Resource Consent No. 102.2026.59.1 response to request for further information

Resource Consent No. 102.2026.59.1
Section 92 Request for Further Information
Canterbury Regional Council
Seadown Drain & Stopbank Realignment (GLOBAL) -

Figure 2: Existing pit-derived wetland extents (purple) and new drain alignment (green)

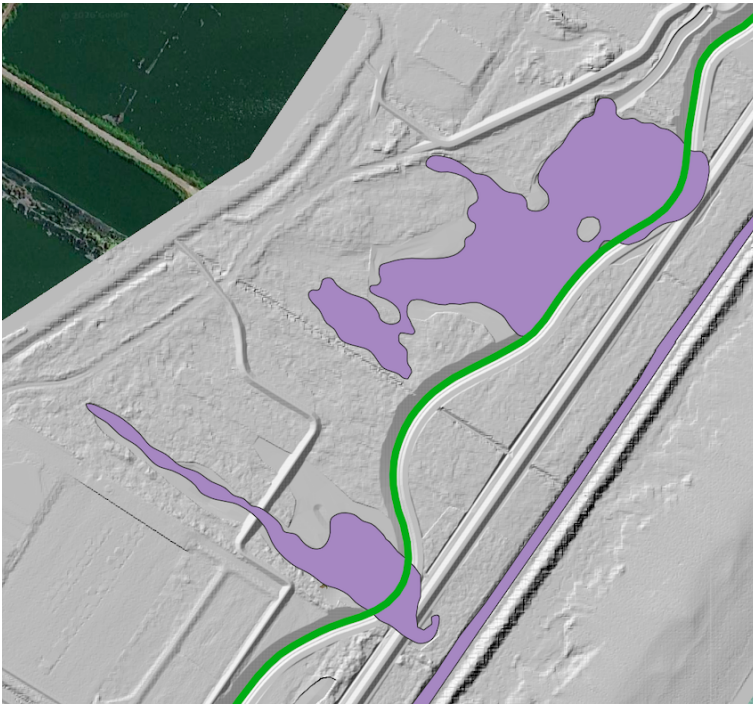
- *area of indigenous vegetation clearance by identified vegetation type;*
- *species list;*
- *mapping of clearance areas;*
- *confirmation whether clearance is limited to pohuehue for Rule ECO-R2 purposes;*
- *ecological assessment of effects arising from indigenous vegetation removal.*

Earthworks and vegetation removal will partially overlap with these wetlands as the alignment passes through their eastern extents (Figure 2 and Figure 3 below). An estimated 0.5ha of rushland may be removed.

The raupō reedland, which is identified as ecologically significant and will be avoided as far as practicable. If works in that area is unavoidable, plants will be relocated to somewhere suitable onsite to support their survival.
